Water Resources Integration Program Pipeline, Segment 1B

Job No.: 14-8604

ADDENDUM No. 1

September 17, 2014

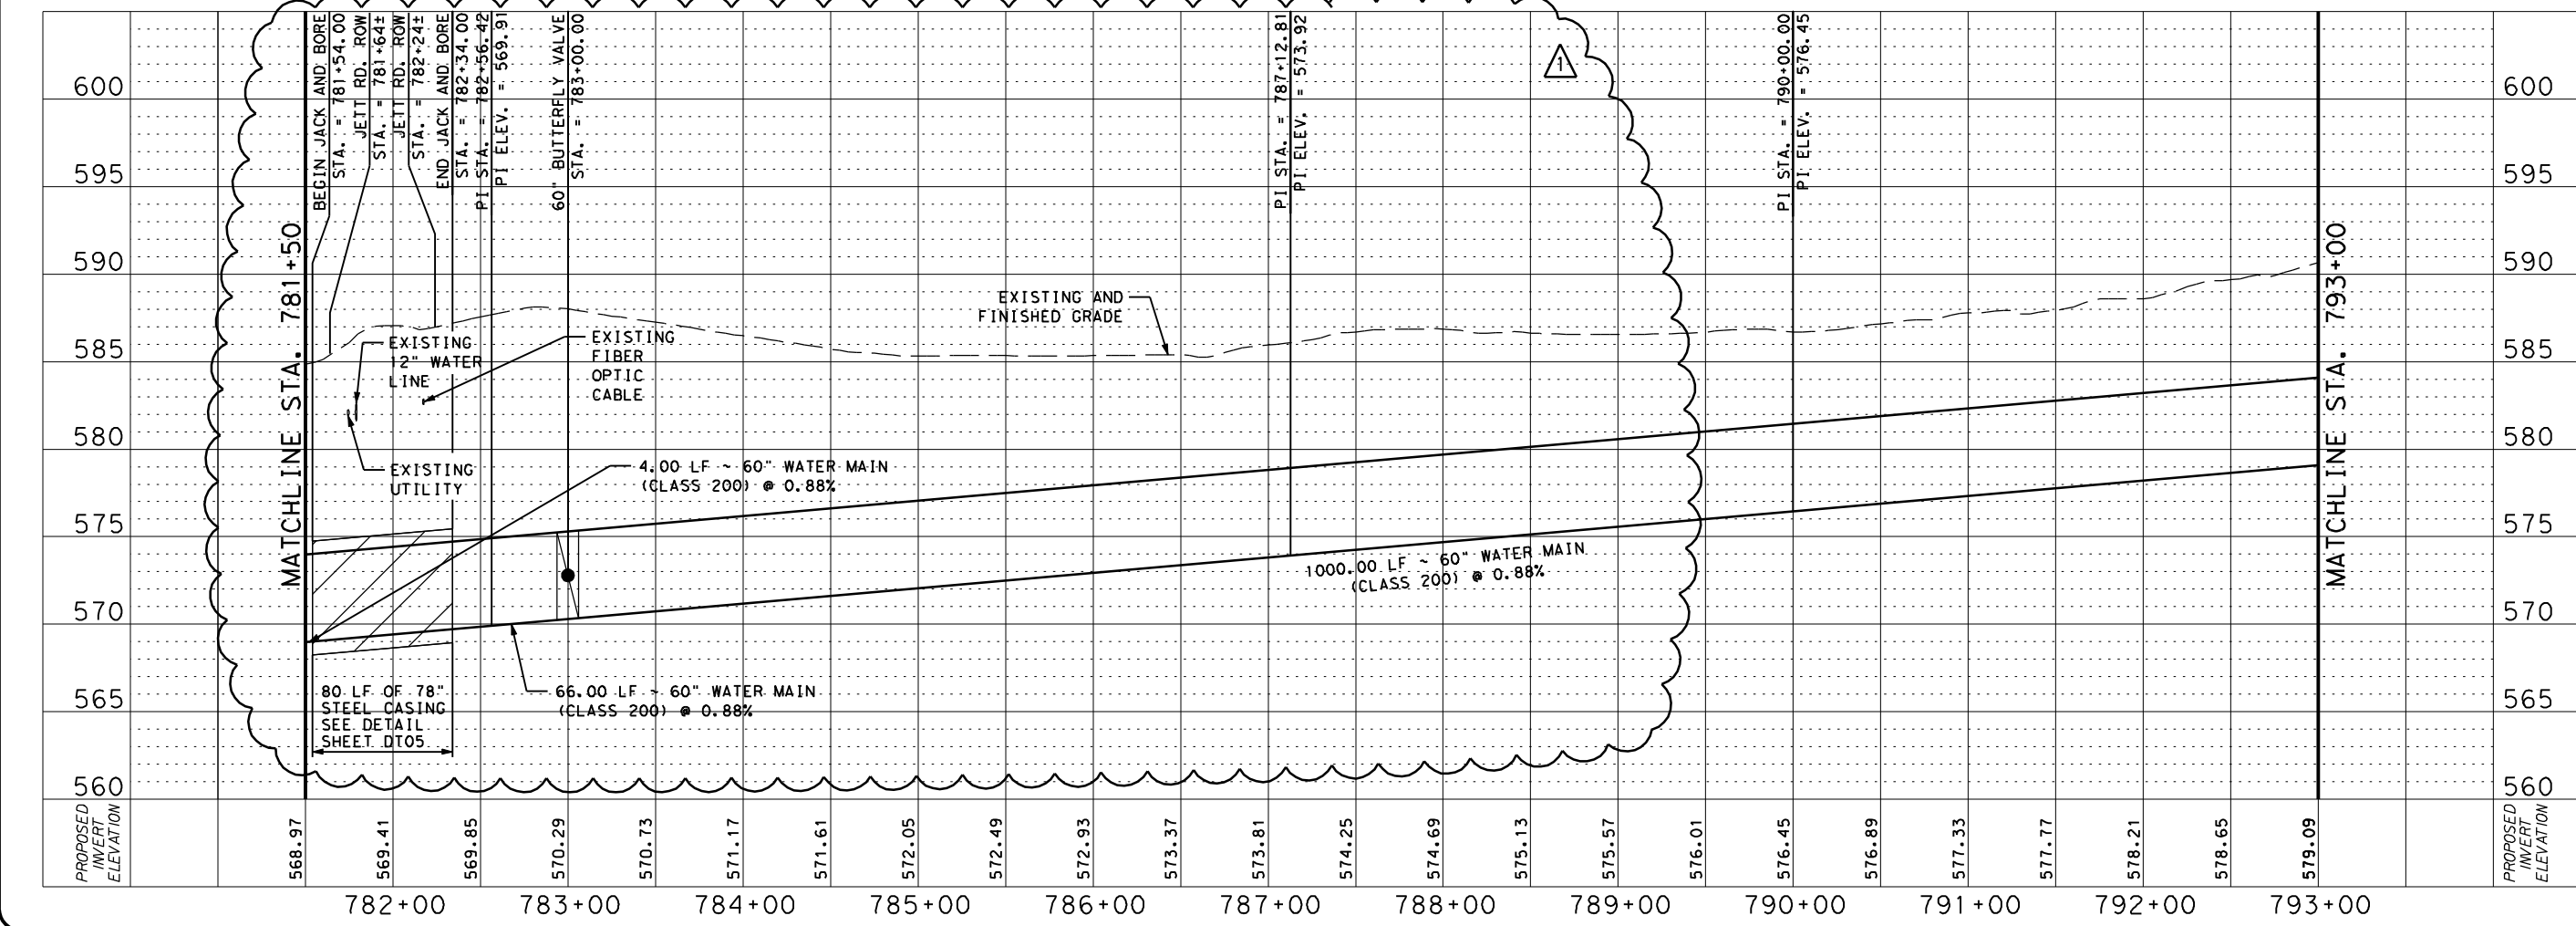
1. Sheets PP17 – PP21. See attached revised drawings.
2. Sheet PP30. See attached revised drawings.
3. Sheet DT02. Remove and replace PIPELINE CLOSURE TESTING AND CHLORINATION REQUIREMENT NOTES 7-10 with these revised notes:
